# Development Services Staff Report for Design Review Committee

**To:** Design Review Committee  
**From:** Jeff Lowe, Planner  
**Subject:** DSRFY2016-10 – Multi-family Development  
**Date:** March 28, 2016

**Summary: Castle Gourdon Multi-family Development – CS2 LLC:** Corey Swain with CS2 LLC, represented by Bob Unger with ULC Management, LLC, is Design Review approval for Castle Gourdon, a multi-family development. The 19 four-plex buildings (76-units) are proposed on a 8.44-acre parcel (parcel no. S0536141952) located on the east side of Glenwood Street approximately 1,600–feet southeast of the intersection of Glenwood Street and Chinden Boulevard, directly south of the Fred Meyer Store at 5425 Chinden Boulevard. The property is zoned Mixed Use (M) and is in the Light Industrial area of the Comprehensive Plan. The application is subject to the approval of a Conditional Use Permit concurrent with the Design Review.

PRELIMINARY MASTER PLAN SHOWING  
CASTLE GOURDON  
LOCATED IN THE SE 1/4 OF THE NE 1/4,  
SECTION 36, T.4N, R.1E, B.M.  
ADA COUNTY, IDAHO  
2016

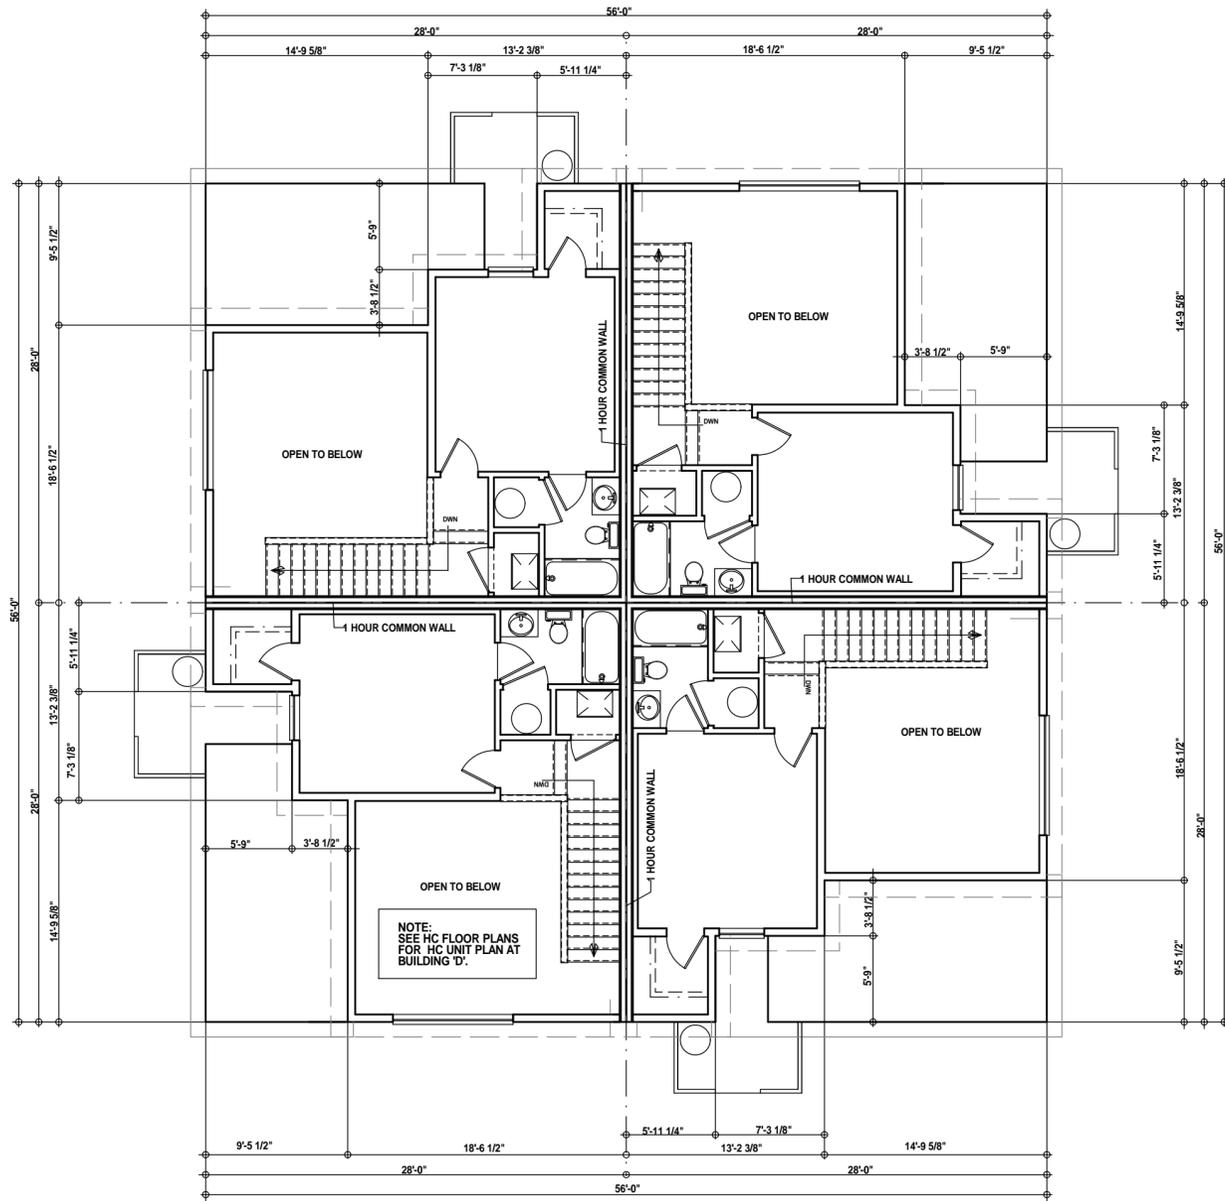
- The applicant has proposed 152 parking spaces (96 covered). Garden City Code 8-4D-5 requires 1 space/unit for one bedroom units and 2 spaces/two bedroom units and an additional .5 spaces/unit for guest parking. With 76 two bedroom units, 152 spaces is adequate except that the guest spots have not been calculated, thus the proposal is 38 spaces shy on-site. The Ordinance also requires that each unit provide a space in a garage; only 96 of the 152 spaces are proposed in carports.

9 bike racks are shown on the plans although it is not indicated how many bikes each rack will hold. The ordinance requires 1 bike space for every six (6) dwelling units; this development is required to have 13 spaces.

The applicant should install more trees along the parking spaces between the sidewalk and adjacent buildings to meet the required ratios and provide a greater "street tree". It should be noted that carports may hinder tree plantings in some areas.

- The applicant should designate where the central mailbox and directory map will be located.
- The applicant should provide details of the proposed 53<sup>rd</sup> Street improvements (curb, gutter, and sidewalk).

- The applicant should provide design details of the proposed carports.
- The applicant should remove the discrepancy between site plan and landscape plan showing a four-plex accessing Glenwood Boulevard.

**FOURPLEX - TYP. UNIT FLOOR PLANS**

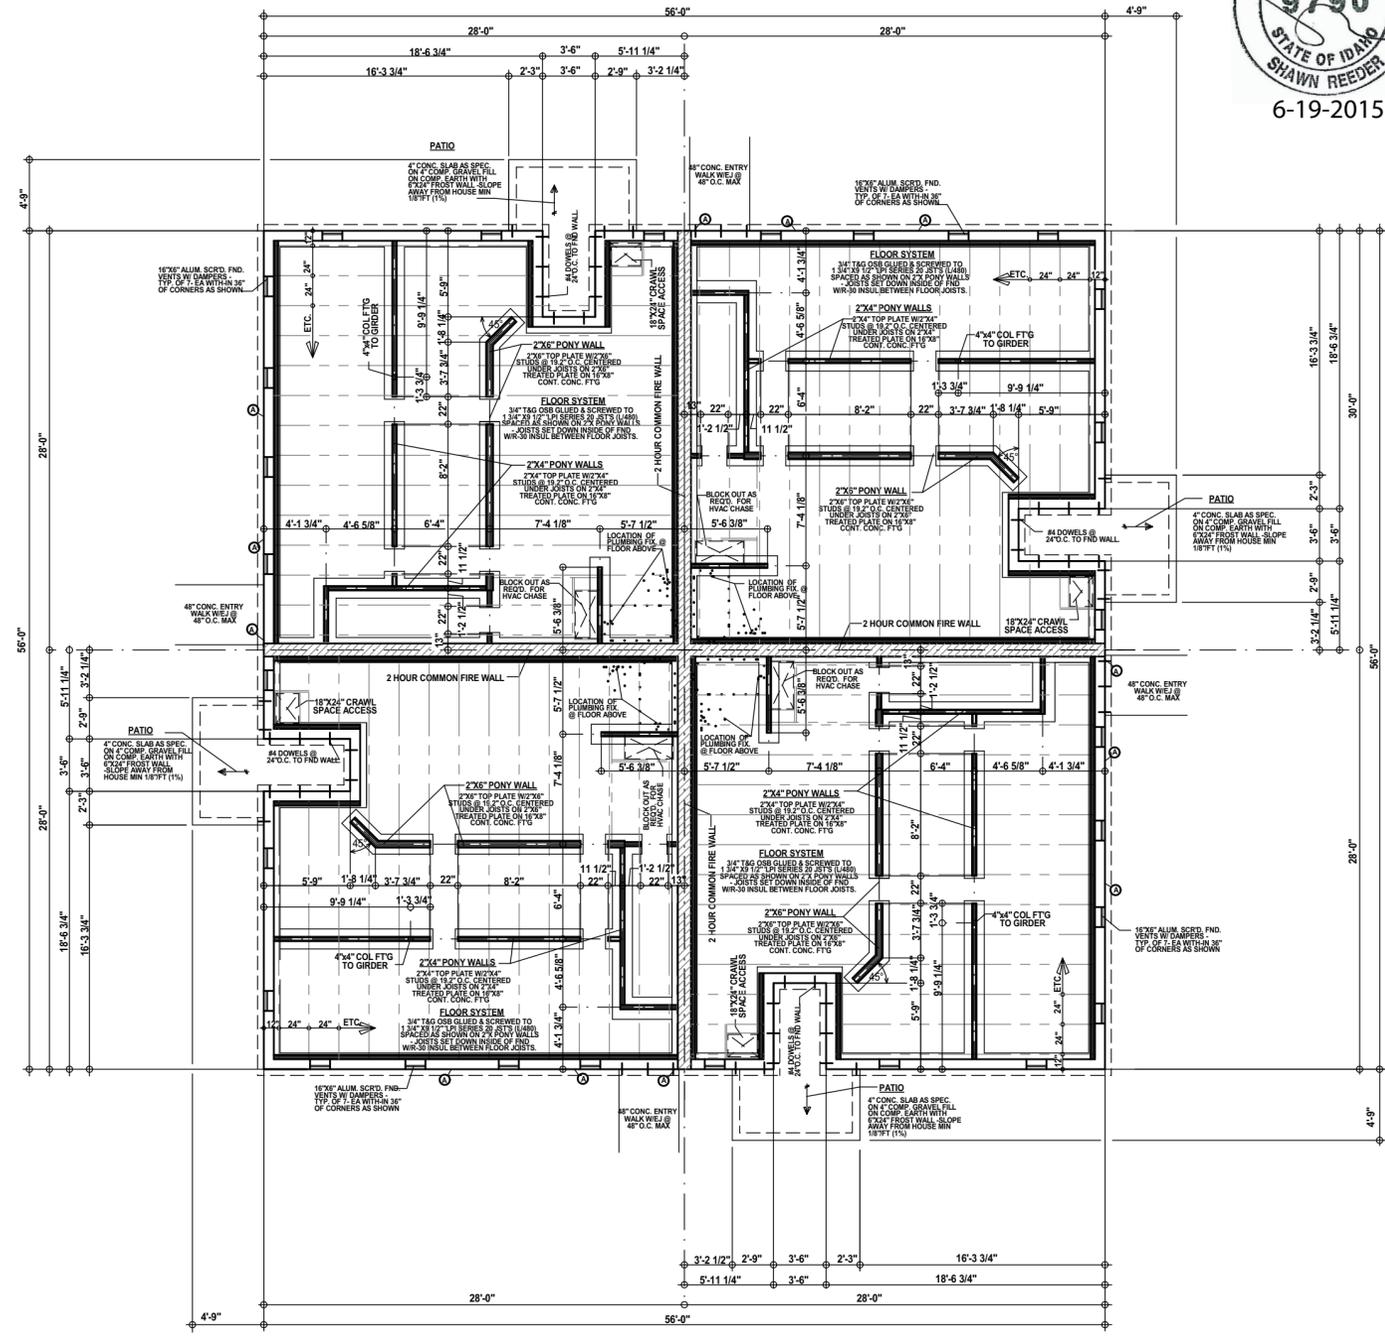
- Each unit is required to have a minimum of 80SF of private open space. While the architectural sheet states the patio area is 60SF, it appears the patio is inclusive of the entryway into the dwelling – not necessarily functioning as a patio. The applicant should clarify which area is the patio and that it is 80SF minimum.
